LIFT TYPE: Hydraulic passenger lift with mirror fitted in the lift car

Mirror Packaging and PVC trims:

(Lower mirror trim shown)

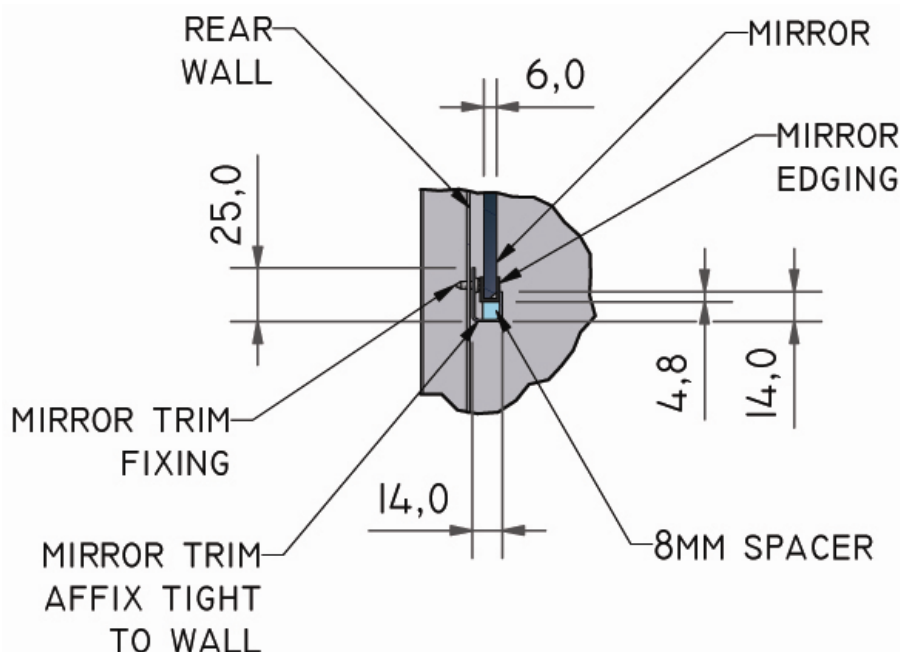
Following the introduction of the new interior lift cars a new mirror fixing method was also introduced. This evolved a slight change to the s/steel mirror trims and the addition of plastic PVC edging to the top and bottom edges of the mirrors. The PVC edging remains on the mirror during installation and is inserted into the mirror trims (see diagram below).
